Model: N-C1/C2: Paper Cassette Type240		Date: 12-Oct-10	No.: RB125021
Subject: Paper Cassette		Prepared by: F.Noguchi	
From: 2nd Overseas Tech Support Sec., 2nd PQM Dept.			
Classification:	<input type="checkbox"/> Troubleshooting <input checked="" type="checkbox"/> Part information <input type="checkbox"/> Action required <input type="checkbox"/> Mechanical <input type="checkbox"/> Electrical <input type="checkbox"/> Service manual revision <input type="checkbox"/> Paper path <input type="checkbox"/> Transmit/receive <input type="checkbox"/> Retrofit information <input type="checkbox"/> Product Safety <input type="checkbox"/> Other ()

Model: Paper Cassette Type 240 for N-C1/C2/C3		Date: 5-Apr-13	No.: RB643001
Subject: Tube: AWG2: B: 300V		Prepared by: F.Noguchi	
From: PP Technical Service Dept 2nd PP Technical Service			
Classification:	<input type="checkbox"/> Troubleshooting <input type="checkbox"/> Mechanical <input type="checkbox"/> Paper path <input type="checkbox"/> Product Safety	<input checked="" type="checkbox"/> Part information <input type="checkbox"/> Electrical <input type="checkbox"/> Transmit/receive <input type="checkbox"/> Other ()	<input type="checkbox"/> Action

Change:

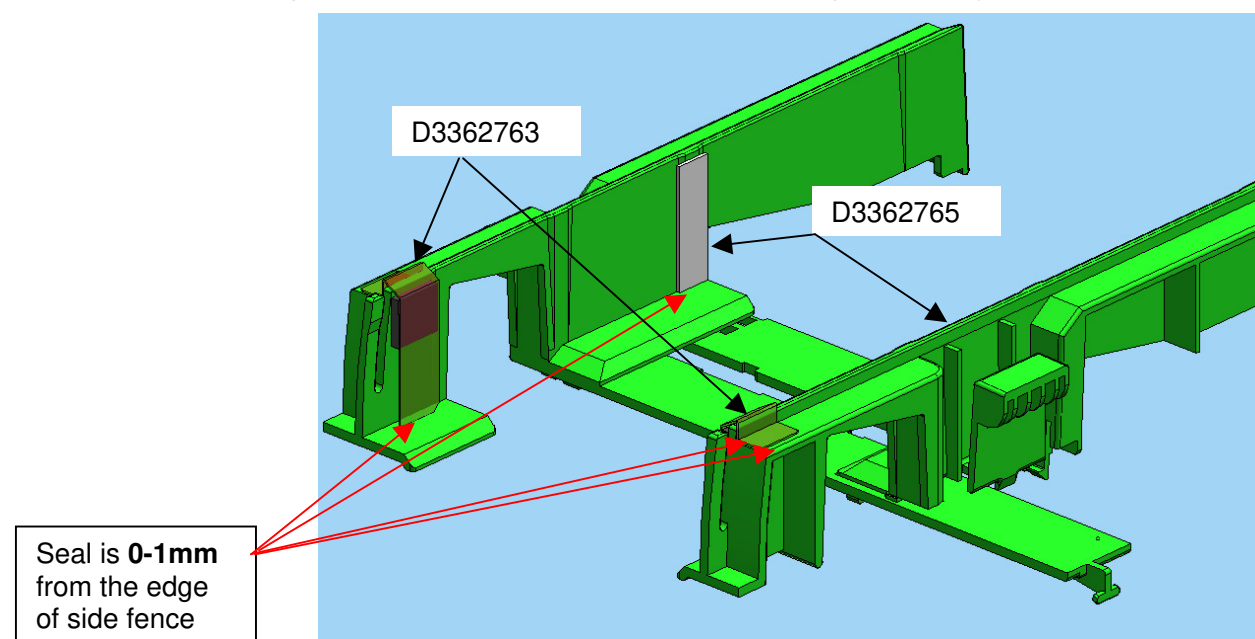
- 1) The shape of the side fence seal was changed (width increased from 8mm to 14mm).
- 2) The material of the left plain shaft bearing in the paper feed section was changed.

Note: Due to this, the color was changed from white to black.

Reason: To further improve paper skew correction.

- Before attaching this seal, clean the attachment surface with alcohol.
- Attach the seal/pad so that the clearance between the seal/pad and edges is between **0-1mm**.
